Network Video Recorder
Version: V4.1.50 build180227
Release Note
(2018-03-20 External)

Firmware Basic Information	Firmware Version:	V4.1.50 build180227
	SDK Version:	V5.3.5.16 build20180129
	ONVIF Protocol:	V 2.5.0
	IVMS-4200:	V2.6.7.1 build20180131
	Web component:	V3.0.6.36build180209

3. 【NVR adds NVR】

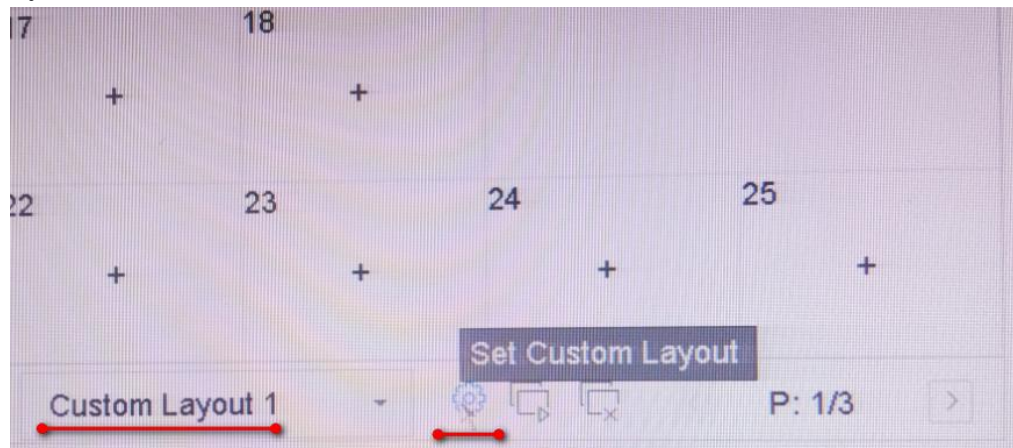
NVR can be added to NVR, and only getting video stream from NVR is supported.

5. 【Custom split screen】

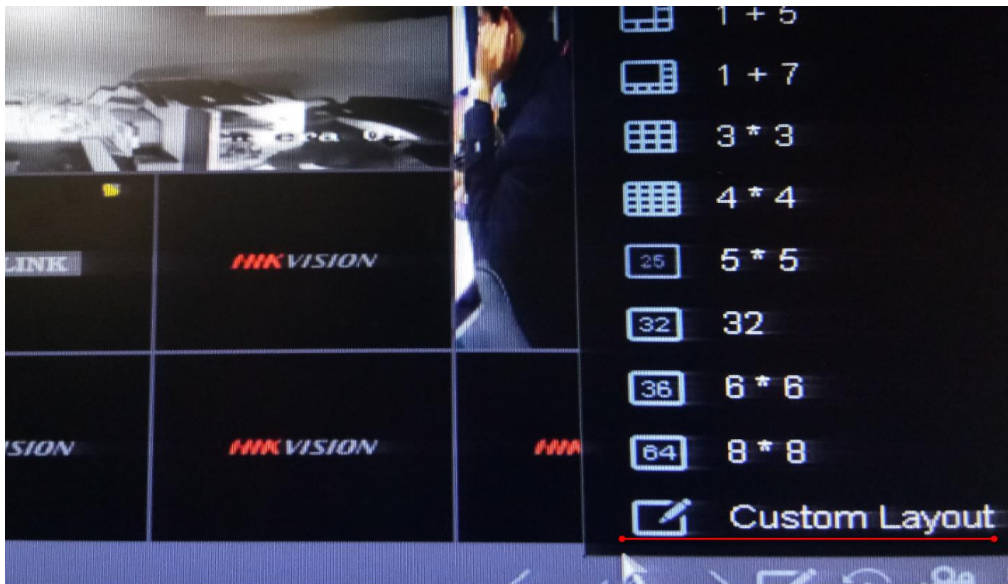
Add custom mode in video split screen configuration interface, as shown in the figure below.

7. 【POE】

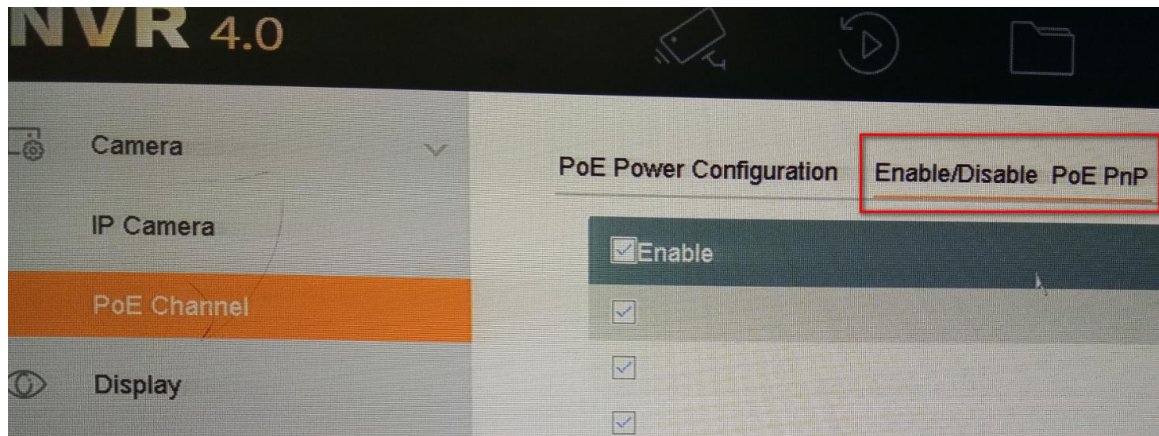
- (1) NVR that has PoE port is able to add IPC automatically when IPC connects with switch and switch connects with one PoE port of NVR.
- (2) The PoE channel can be enabled or disabled.
Camera – Camera – IP camera

8. 【Video synopsis】

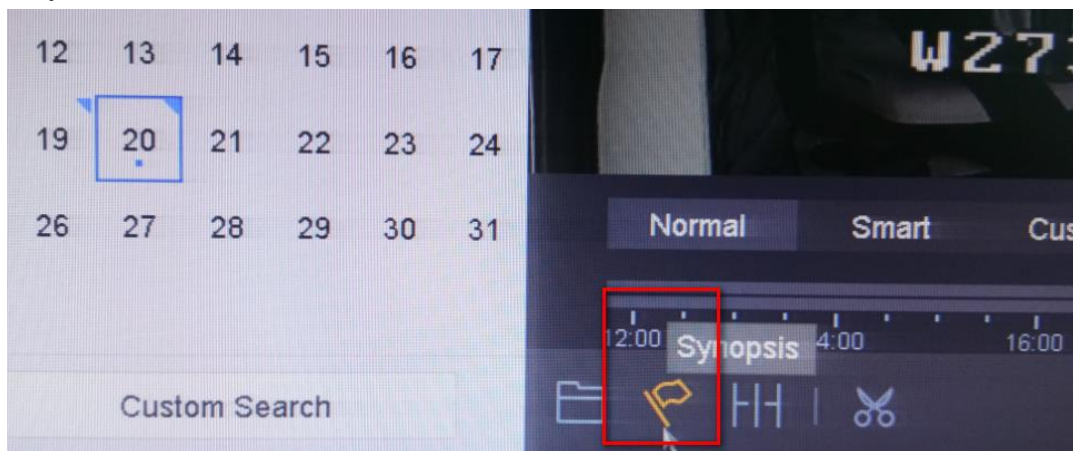
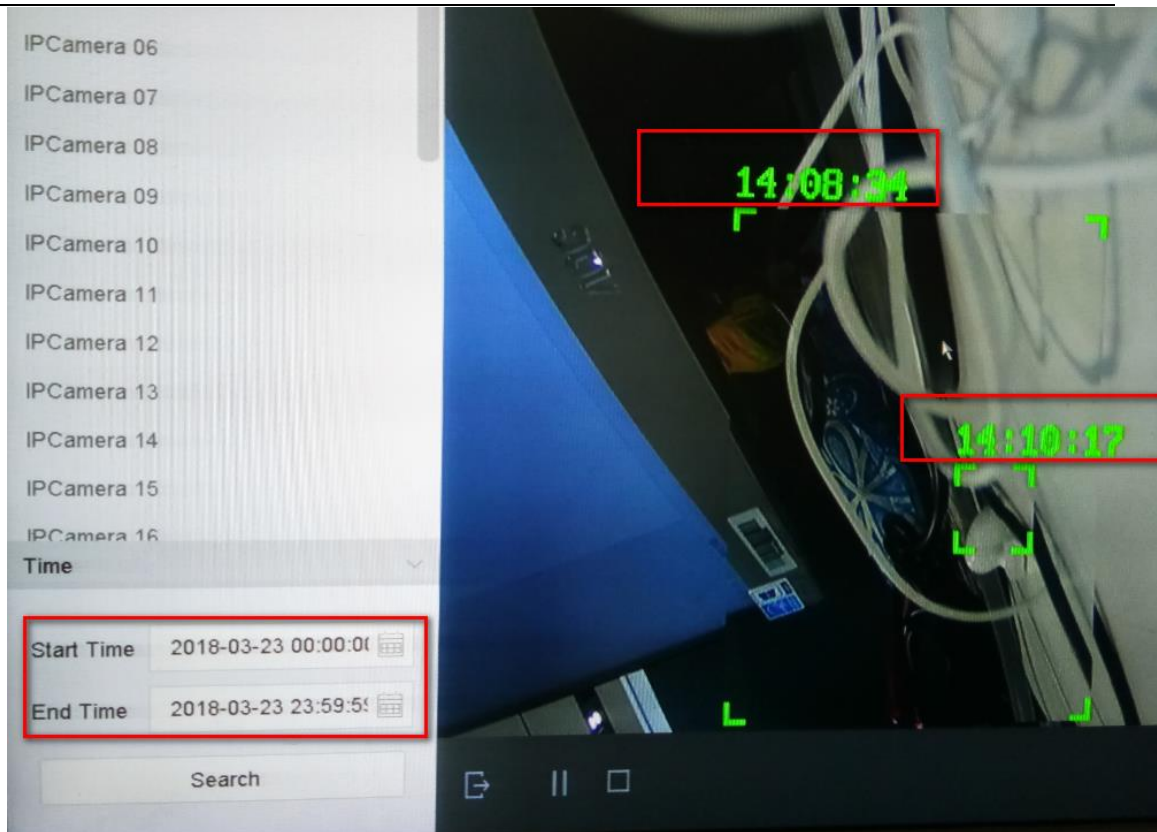
(1) After setting video synopsis, the track of VCA recognition area in the video is displayed.

(2) Video synopsis and face capture mutually exclusive.
